# SERVICE BULLETIN

DATE: May 18, 2026 Service Bulletin No. 668

SUBJECT: Starter Wire Contact with Fuel Servo.

MODELS AFFECTED: IO-390-C3B6 with 61P31530 (Airflow Performance) Fuel Injection Servo and 31B26554 (Skytech 149NL-EC) Starter installed.

**Figure 1:**

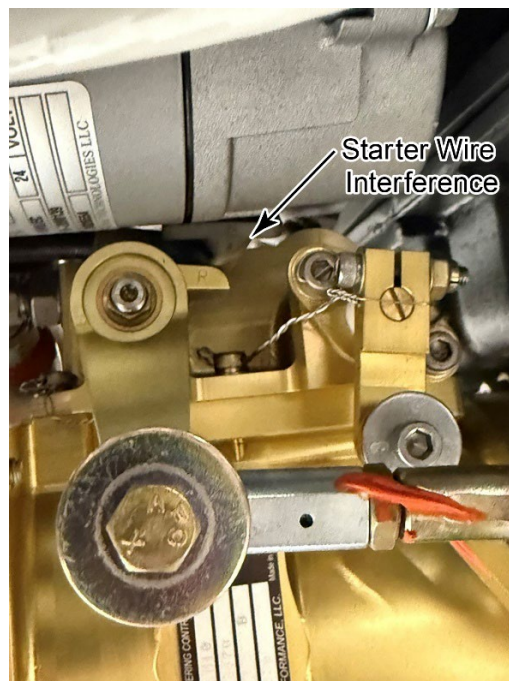
Inspect for clearance between the mixture control and starter wires. No contact should exist with full actuation of the mixture control, refer to figure 1.

**Figure 2:**

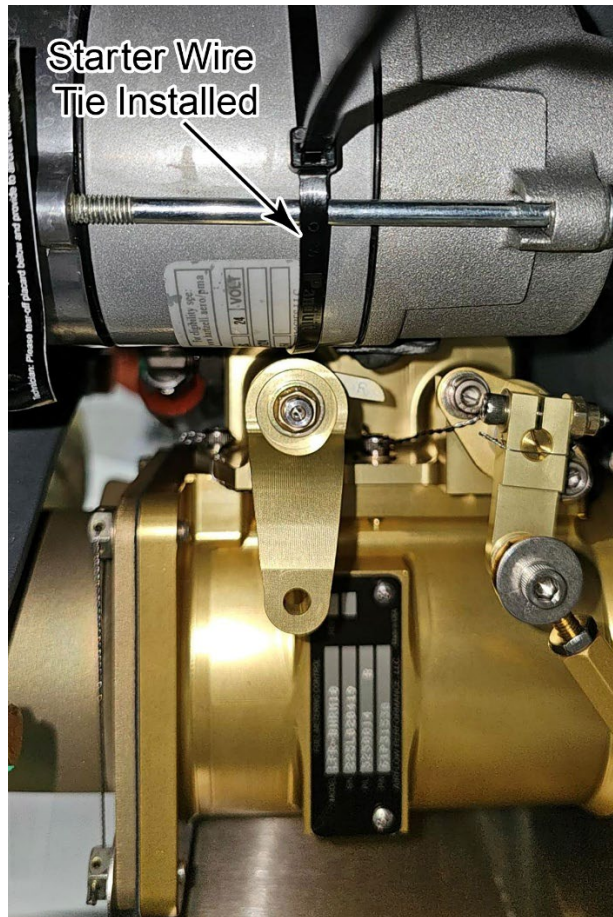
Install high temp zip tie over starter and starter wire to create gap between starter wire and fuel servo. Routing and securing should prevent the wiring contact even when deflected by gentle hand pressure, refer to figure 2.

Use Fastenal, PN PLT4S-M30 or equivalent tie.

Inspect zip tie annually or in 100hr intervals, whichever comes first until terminating action is applied.

**Terminating action will be installing a 31B26553 (Hartzell 149NL/ECM) starter.**
